CHAPTER 343, HRS
Environmental Assessment (EA)/Determination
Finding of No Significant Impact ✓

**APPLICATION FOR SHORELINE SETBACK VARIANCE
AND
FINAL ENVIRONMENTAL ASSESSMENT**

Reconstruction of Seawall

Zane Property, TMK (1) 6-8-10:23 (Lot 14)
68-695 Farrington Highway, Mokualeia, Oahu, Hawaii

Figure 2

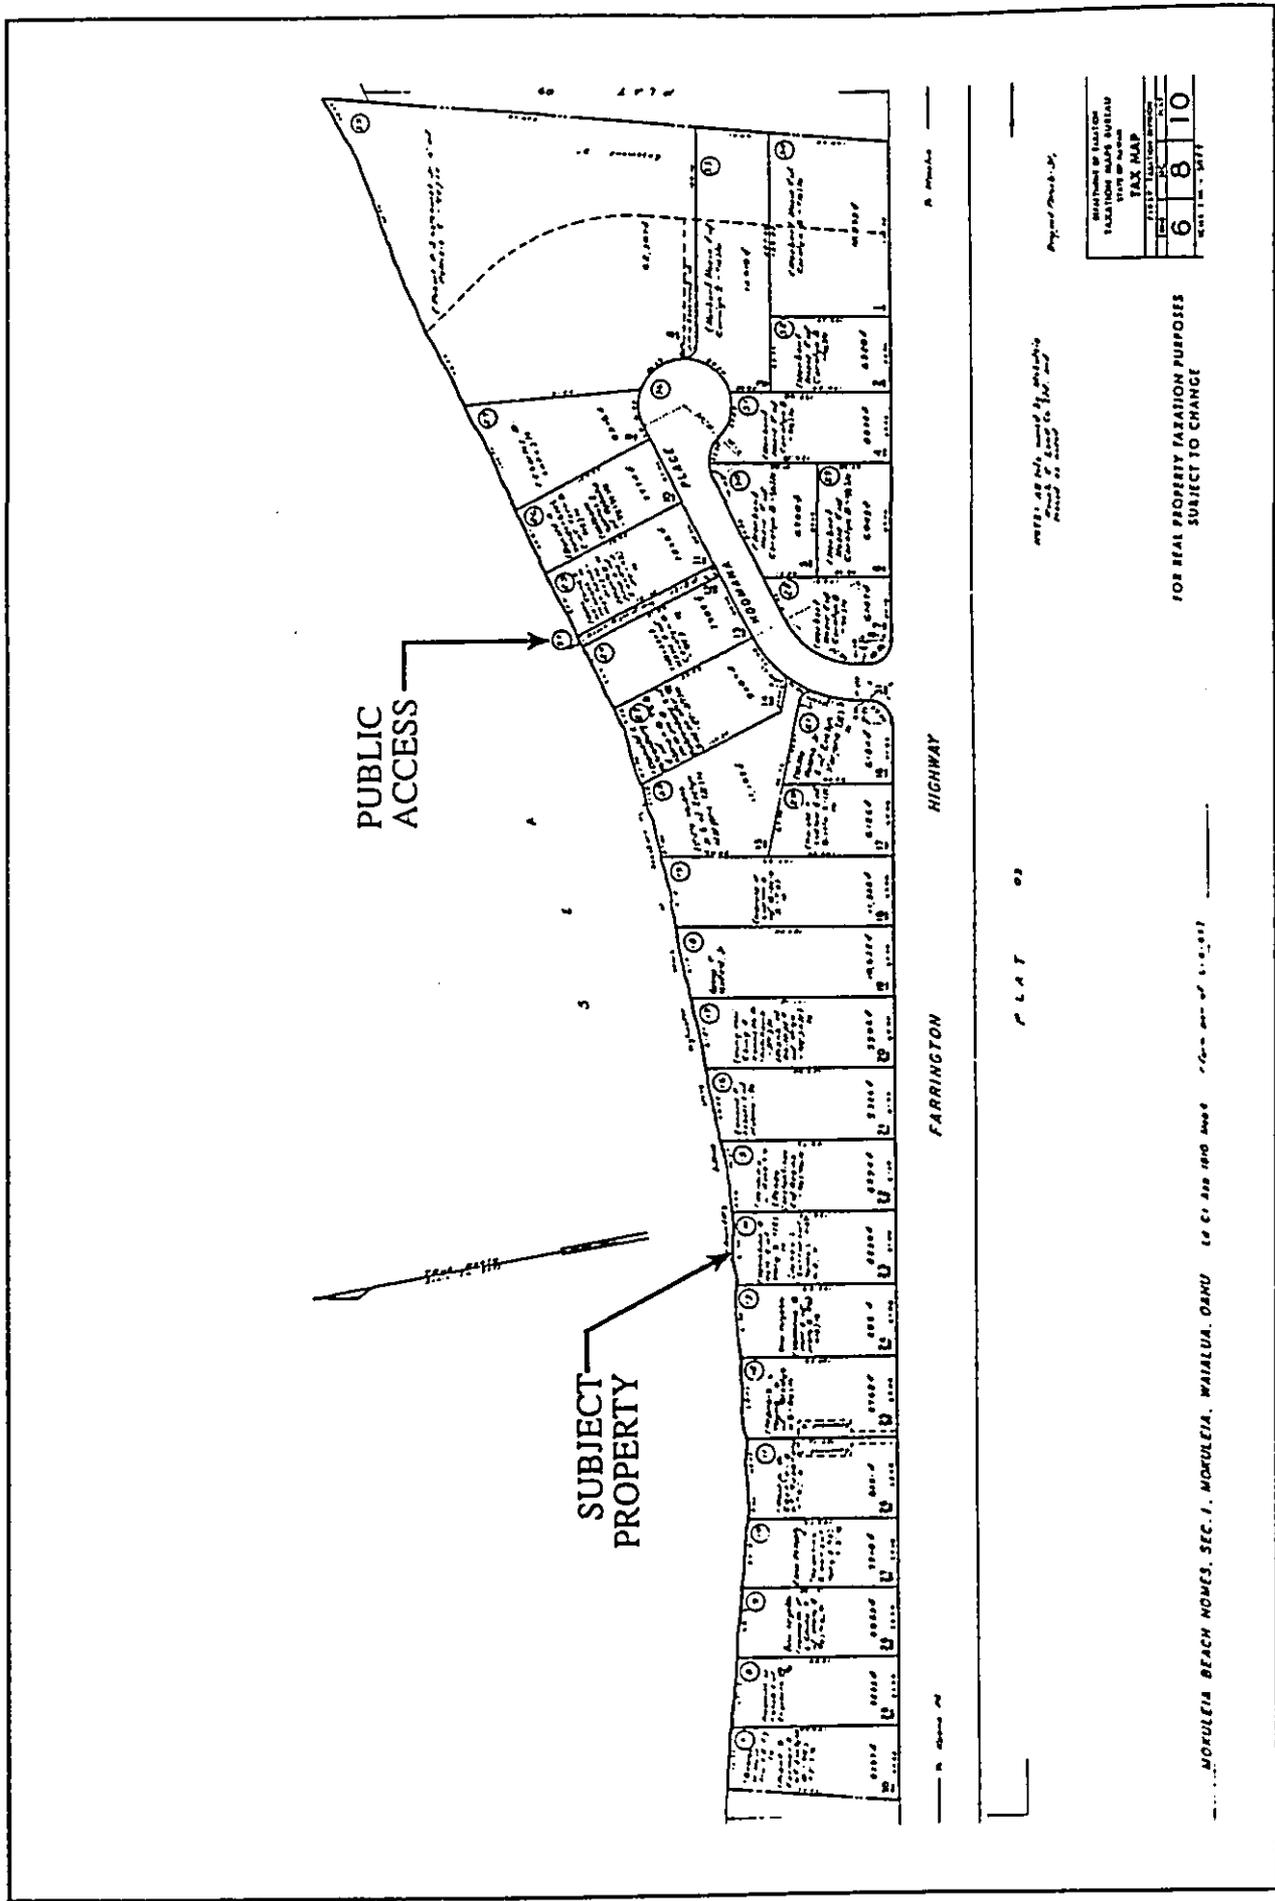
3. Site maps that clearly show the current certified shoreline, previous certified shorelines, the private property line and the location of the proposed structure. Any nearby public access right-of-way should also be depicted.

- 1) **Public Access.** The closest public access right-of-way is depicted in the TMK map shown in Figure 2. An access easement is found approximately 500 feet to the east off Ho'omana Street.

Typical CRM
Modified Seawall Section
Source: TNWRE, 1997

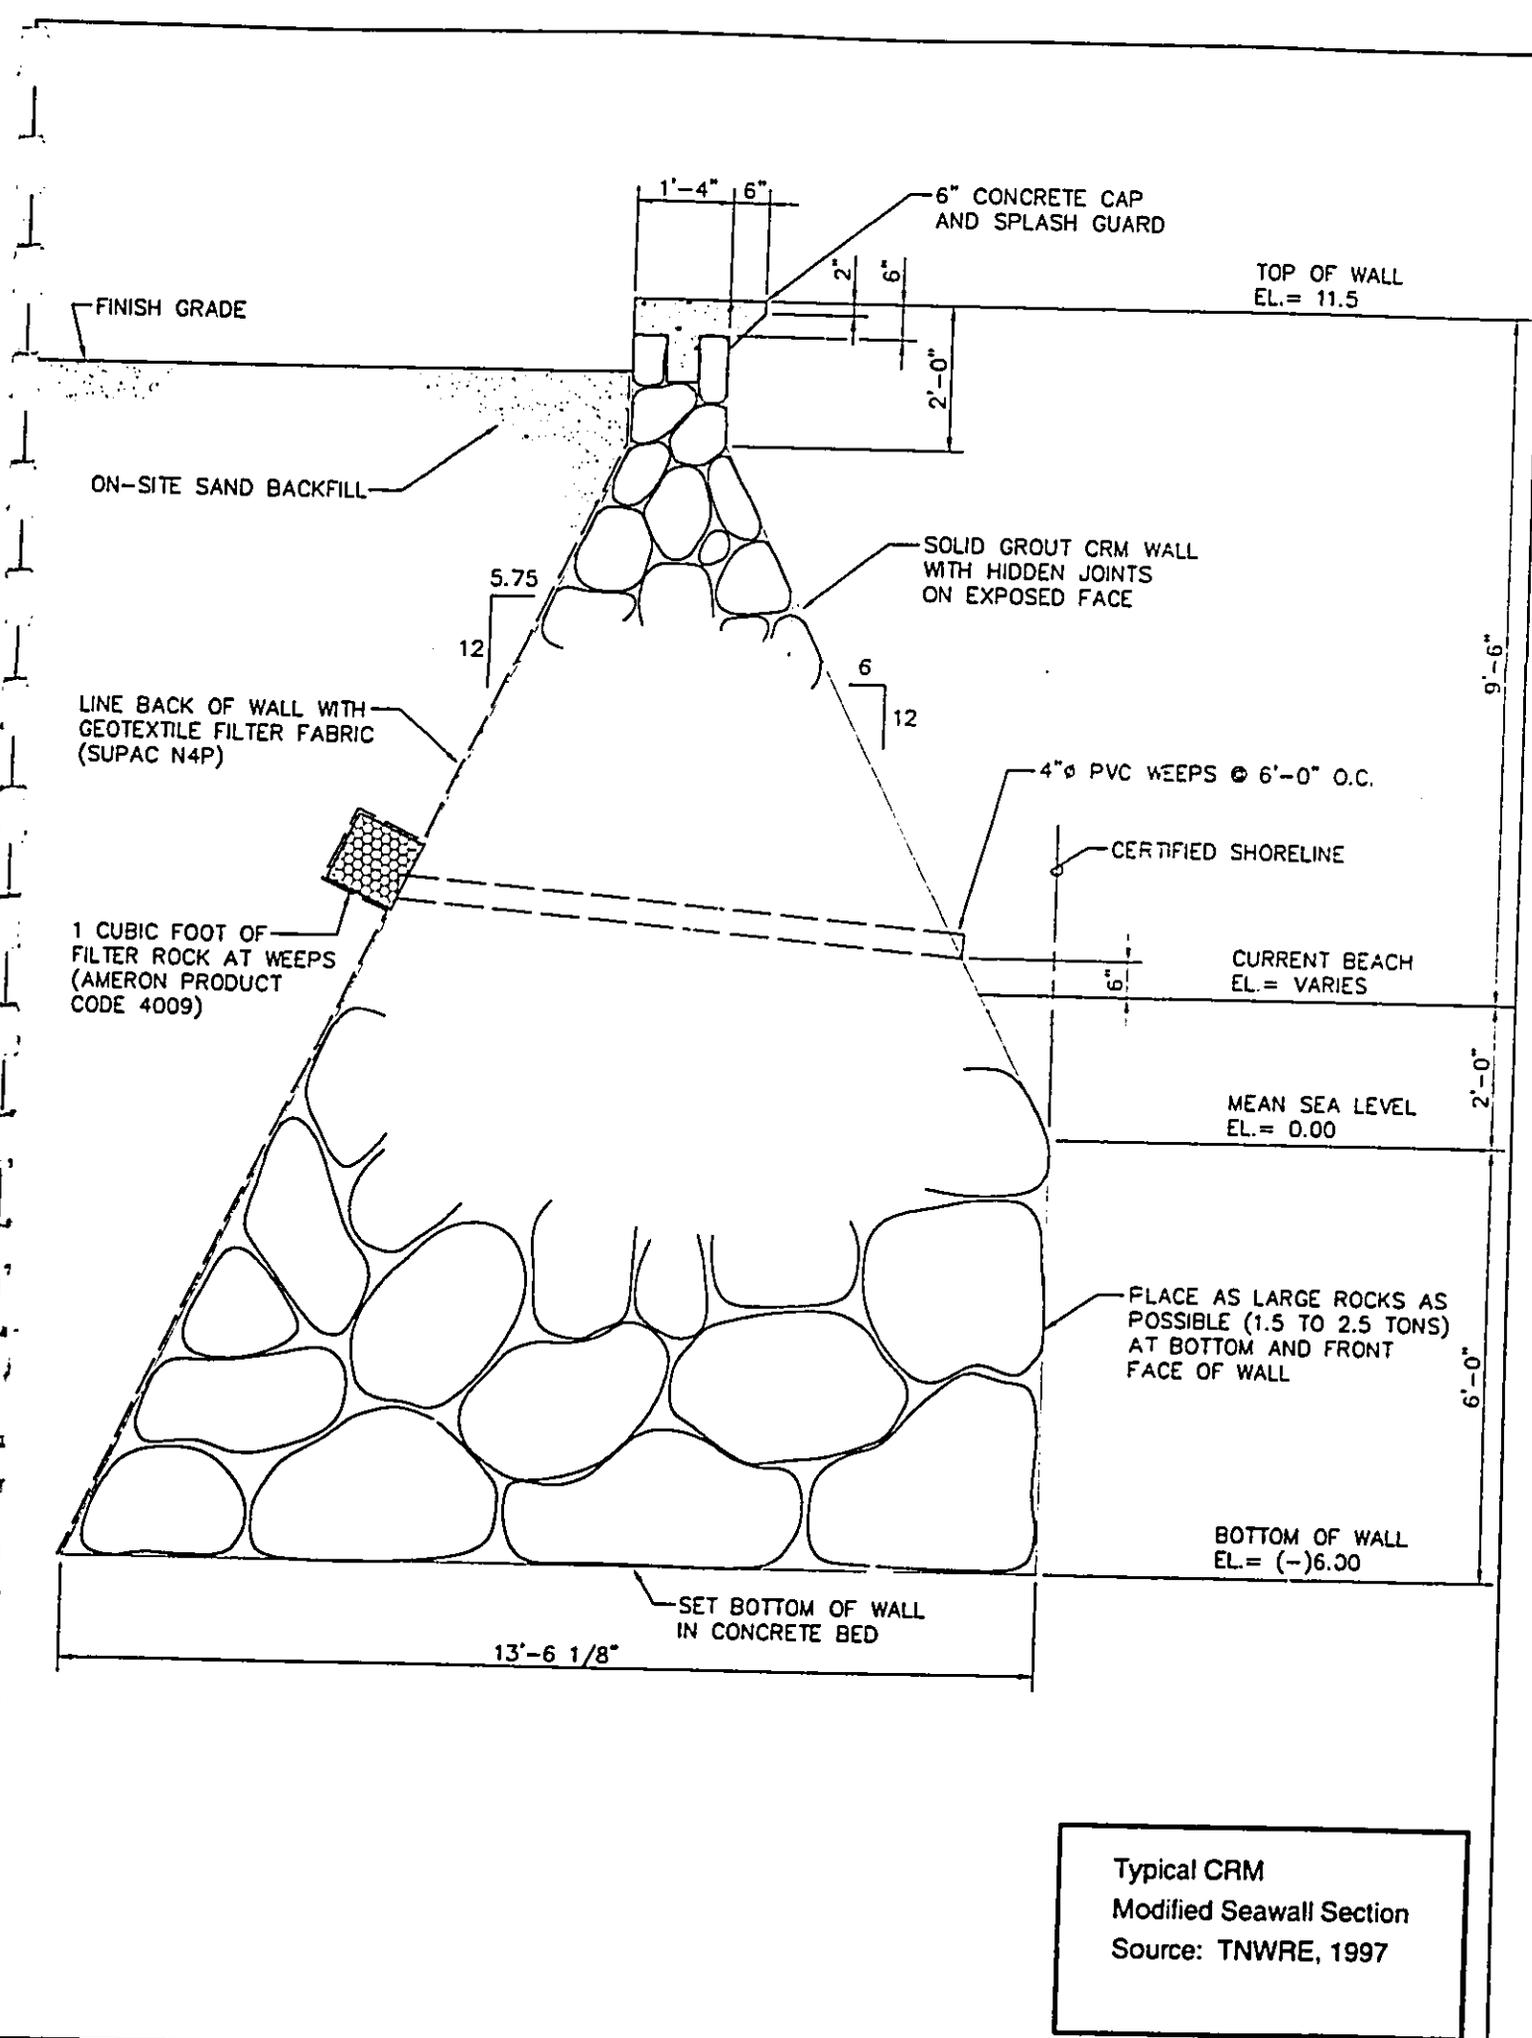
Figure 7 in the DEAs illustrate the design of the proposed seawall structures. The tops of the proposed seawalls are only 1' 10" wide. This hardly seems adequate to allow "safe" lateral access to the shoreline especially during times of high surf events. The proposed seawalls should be designed to allow shoreline access without presenting a safety hazard to the public.

2. **Lateral Shoreline Access.** The four seawalls are aligned together and match the adjoining properties on either side. At this location, there are 16 properties in a row that are all protected by vertical seawalls. The beach along this entire section of the Mokuleia coast could be considered very narrow. Lateral passage along this shoreline in front of the seawalls will be improved by the proposed action, which will remove loose rock debris and deteriorated wall sections, and replace these with an engineered modified vertical seawall structure. With the lower sloped portion consisting of large rock material, there will be a return of a slightly wider beach for lateral passage. At the three lots to the west where modified vertical seawalls were recently built with the hybrid wall design, there has been a recent return of a narrow strip of beach sand along a section where there was no beach sand for lateral passage in the recent past.
